US 29 BRT - SLIGO CREEK PARKWAY TO TECH ROAD

MANDATORY REFERRAL NO. MR2026016

This is a Mandatory Referral review of a Montgomery County Department of Transportation (MCDOT) project to construct a series of median-running bus rapid transit (BRT) lanes for approximately five miles along US-29 (Colesville Road) between Sligo Creek Parkway and Tech Road, connecting Silver Spring and Briggs Chaney.

Figure 13: Existing Speed Limits Along US-29

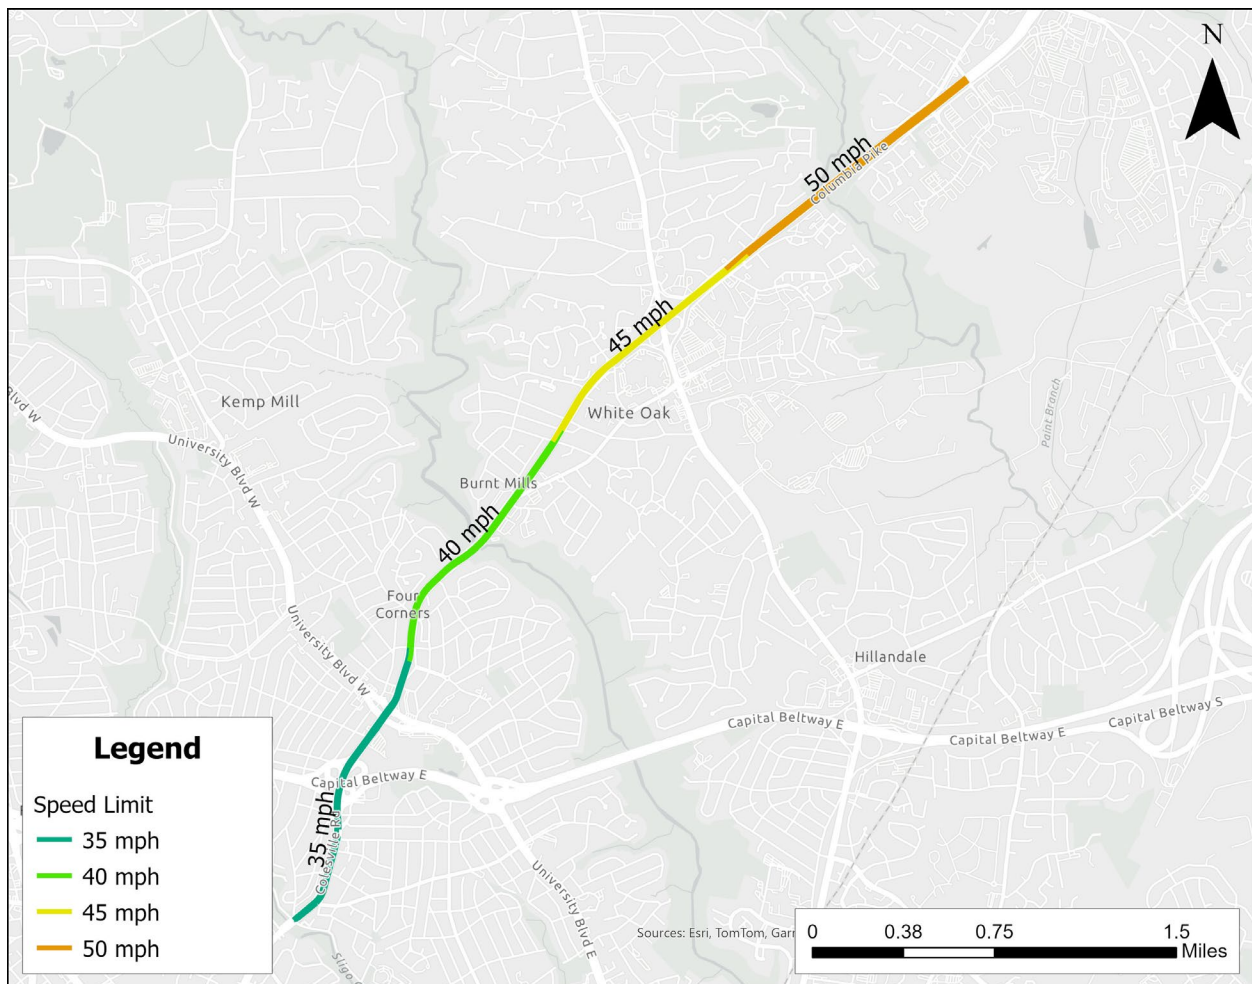
Comment: Consider additional measures to lower posted speeds throughout the corridor so motor vehicles travel at the master-planned target speed.

Figure 24: Project Proposed Realignment of Lockwood Drive

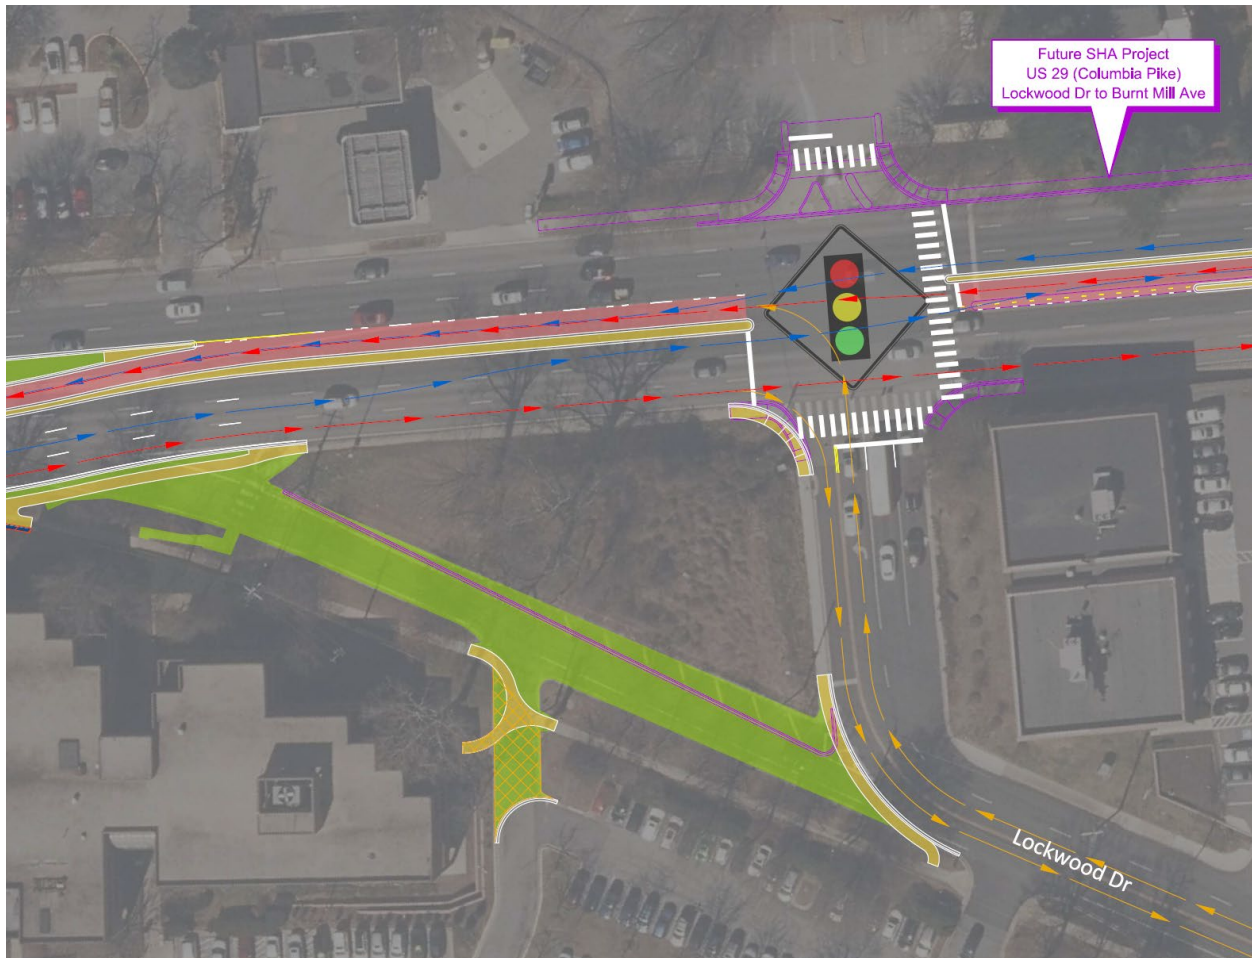
Comment: Construct the master-planned breezeway sidepath in the portion of Lockwood Drive the project is removing.

While standalone bikeway projects are best considered as part of the separate capital project, there is one opportunity MCDOT should pursue as part of this project. The Burtonsville-to-Silver Spring Breezeway transitions from US-29 onto Lockwood Drive as a sidepath. As shown in Figure 24, the project proposes to close a slip lane that allows northbound US-29 traffic to turn right onto Lockwood Drive. In the proposed condition, right-turning vehicles instead turn at the signalized Lockwood Drive intersection.

Rather than close this slip lane connection to all modes, the project team should design and construct the master-planned breezeway sidepath in part of this space. It would facilitate more direct, low-stress pedestrian and bicycle access to the Burnt Mills Flash stations and take advantage of the decision to make roadway changes at this location to implement a high-quality master-planned bikeway.

Figure 26: Existing/Proposed Cross-Section Inside the Beltway

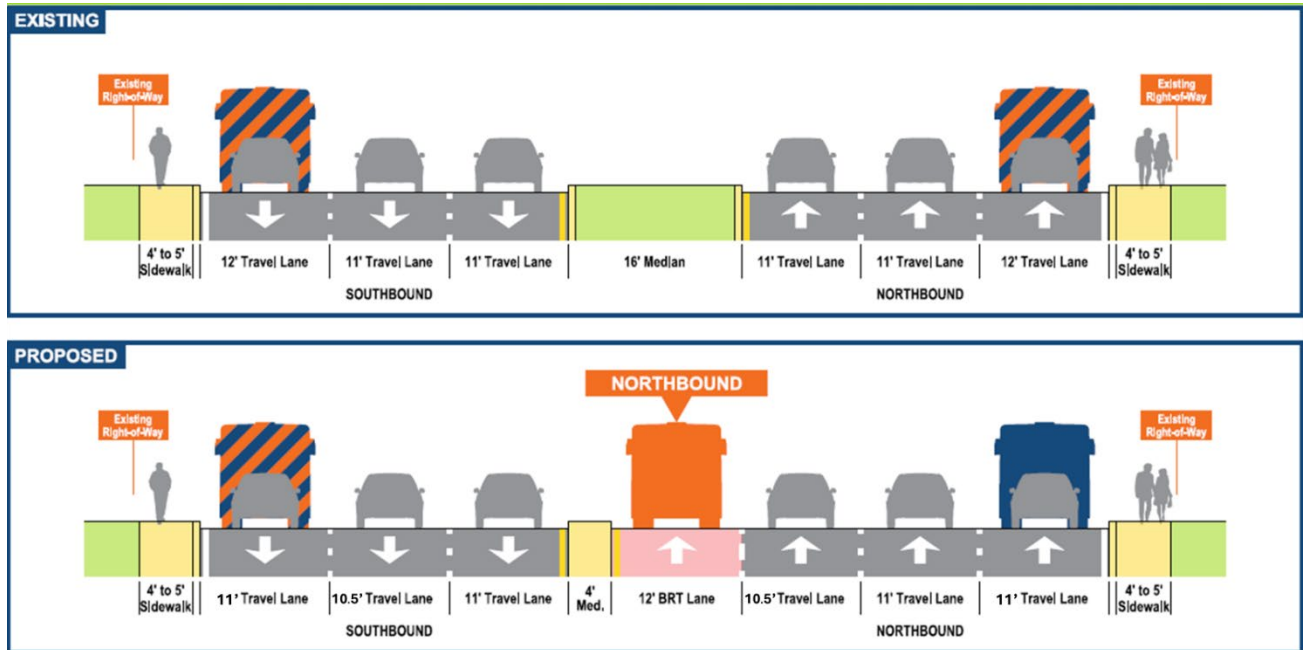
In general, the project’s roadway cross-sections show wider lane widths for the general purpose travel lanes (inside and outside) than the Complete Streets Design Guide defaults. Typically, on the Boulevard, Town Center Boulevard, and Growth Corridor Boulevard segments between Sligo Creek Parkway and New Hampshire Avenue, inside travel lanes are shown as 11 feet and outside travel lanes are shown as 12 feet, but there are locations where outside lanes are 11 feet and at least one inner lane is 10.5 feet (Figure 26).

Comment: Narrow travel lanes to default widths and use excess space to provide concrete transit buffers where none exist in the current design.

Figure 27: Existing/Proposed Controlled Major Highway Cross-Section

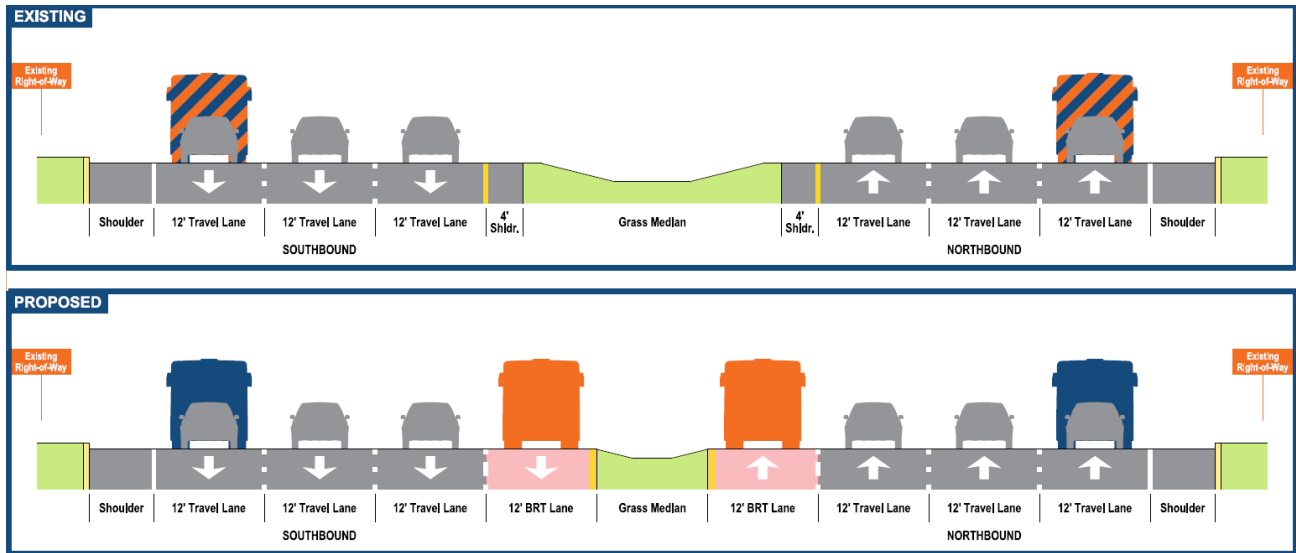
Along the Controlled Major Highway section, all general purpose travel lanes are shown as 12 feet (Figure 27).

Figure 28: Unprotected bus lane location south of Lanark Way

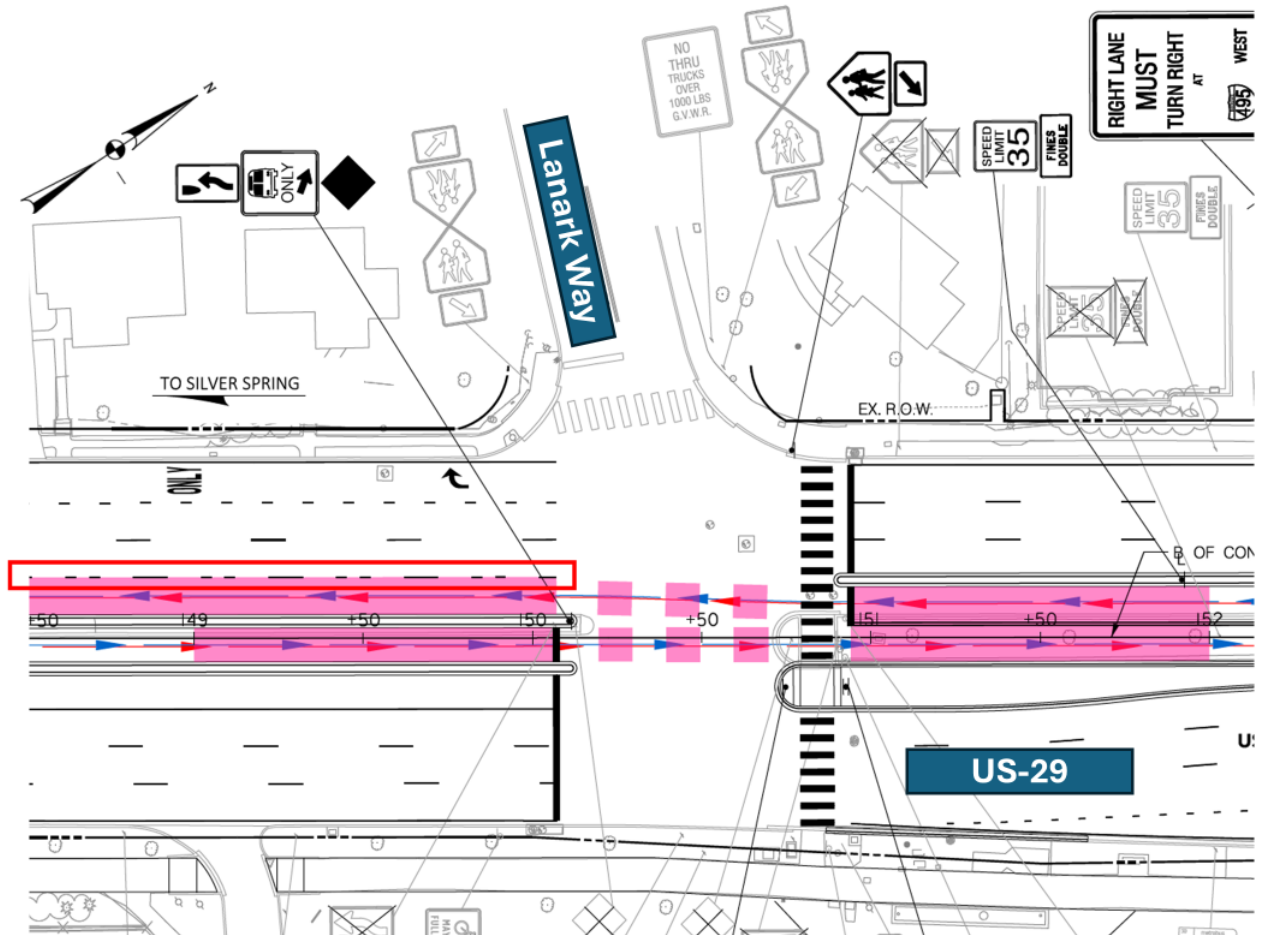
Without additional concrete buffering at certain locations, the dedicated transit lanes will likely be used by opportunistic drivers to bypass congestion, and potentially impede transit vehicles, delaying transit riders and harming the reliability of proposed transit service. Even short segments of additional concrete curbing would be beneficial, like in the highlighted portion in Figure 28 where southbound buses heading toward Silver Spring begin transitioning into mixed traffic south of Lanark Way.

If this section had curbing past the I-495 Outer Loop on-ramp, it would eliminate the impulse of drivers to merge into that lane while driving through the Lanark Way intersection.

Figure 29: Westbound Timberwood Avenue Movements

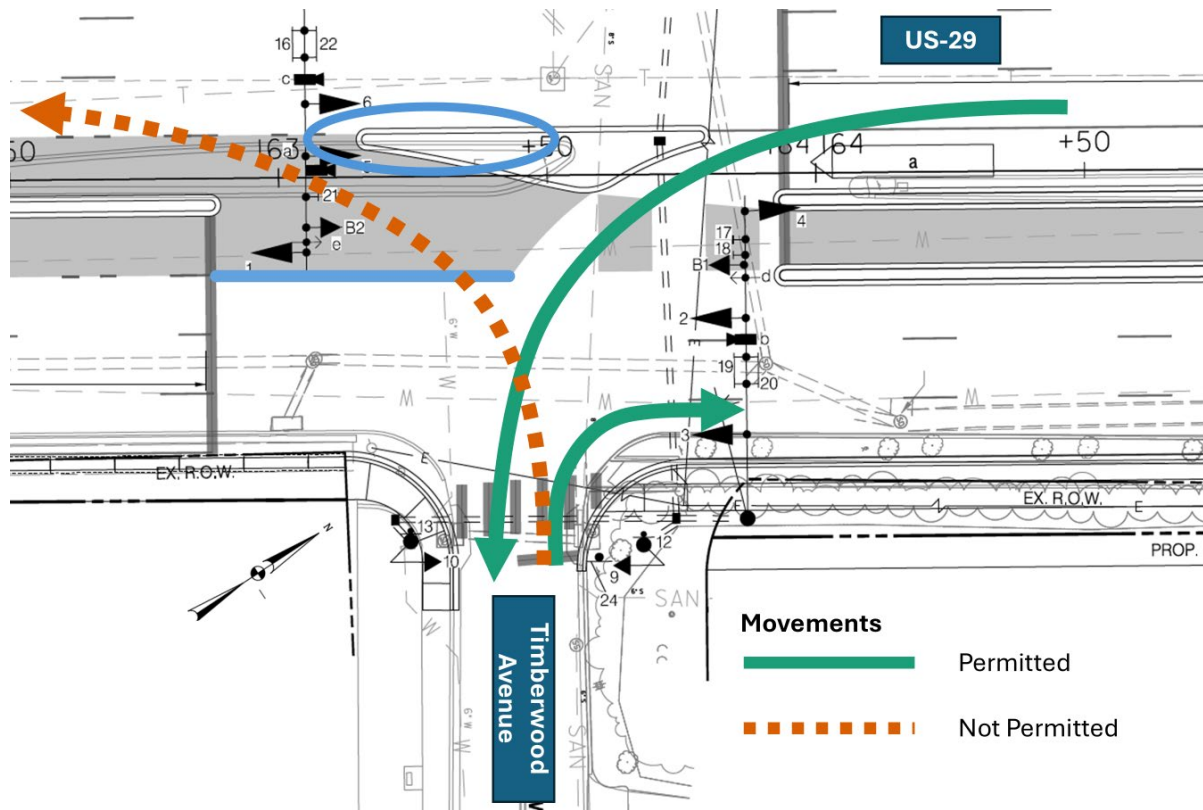
Comment: Consider changes to the US-29 median at Timberwood Avenue to prevent left turns from the westbound approach.

However, the proposed median design allows drivers to turn left from westbound Timberwood Avenue (the dashed red arrow in Figure 29), enter the transit lane temporarily, and then merge into southbound US-29 traffic. The project team should consider extending the triangular median a bit further south to close the gap highlighted by the blue circle in Figure 29. Extending this median a few feet would still provide curb-running southbound buses ample space to enter the dual dedicated transit lanes while removing the temptation to turn left from westbound Timberwood Avenue. Alternatively, designers could add a short curb to the edge of the northbound transit lane highlighted by the blue line in the figure.
